# Access Compliance Report

## Public Rights-of-Way

Intersection ID: 51582	Main Street: QUIVERING_OAK_LN	Cross Street: WESLEY_VILLAGE_RD	Location: NW
ADA ID: A45417D2D30B	Ramp Type: Perp	Initial Pass/Fail: Fail	Overall Compliance: No
Severity Score: 8.75			
Codes/Mitigation Info/Possible Solution		Field Measurements/Component Compliance

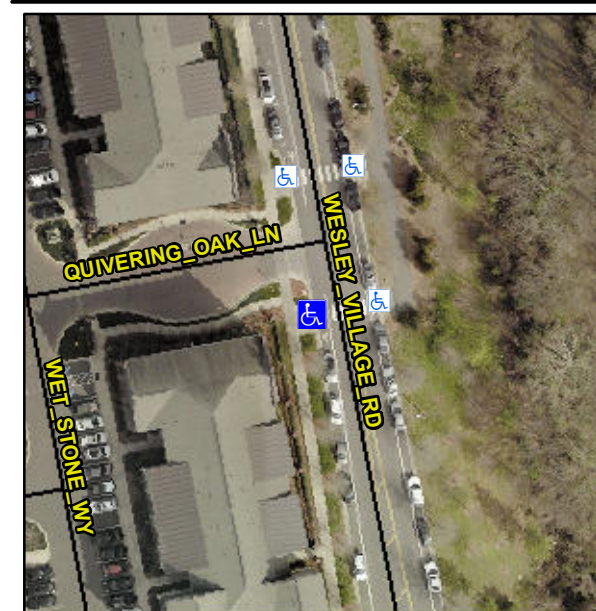
**Not Found, R304.5.1**

Compliance	Description	Data	Compliance	Description	Data
N/A	Ramp Length (in)	97.0	Yes	Ramp Slope (%)	7.1
No	Ramp Width (in)	47.0	Yes	Ramp XSlope (%)	0.7
N/A	Flare Type LT	N/A	N/A	Flare Type RT	N/A
N/A	Flare Slope LT (%)	N/A	N/A	Flare Slope RT (%)	N/A
N/A	Flare Traversable LT?	N/A	N/A	Flare Traversable RT?	N/A
N/A	Landing Length (in)	N/A	N/A	DWS Provided?	N/A
N/A	Landing Width (in)	N/A	N/A	DWS Contrast?	N/A
N/A	Landing Slope (%)	N/A	N/A	DWS Length (in)	N/A
N/A	Landing X Slope (%)	N/A	N/A	DWS Full Width?	N/A
N/A	Landing Curb? (Y/N)	N/A	N/A	DWS Offset (in)	N/A
N/A	Shared Landing?	N/A			
N/A	Gutter Ponding?	N/A	N/A	Gutter Slope (%)	N/A
N/A	Gutter Lip Ht (in)	N/A	N/A	Gutter X Slope (%)	N/A
N/A	Painted X Walk1?	Yes	N/A	Painted X Walk2?	N/A
	X Walk 1 Direction	To E		X Walk 2 Direction	N/A
N/A	X Walk 1 Width (in)	96.0	N/A	X Walk 2 Width (in)	N/A
	X Walk 1 Slope (%)	2.6		X Walk 2 Slope (%)	N/A
	X Walk 1 X Slope (%)	1.1		X Walk 2 X Slope (%)	N/A

**Remove & Replace Entire Ramp.**
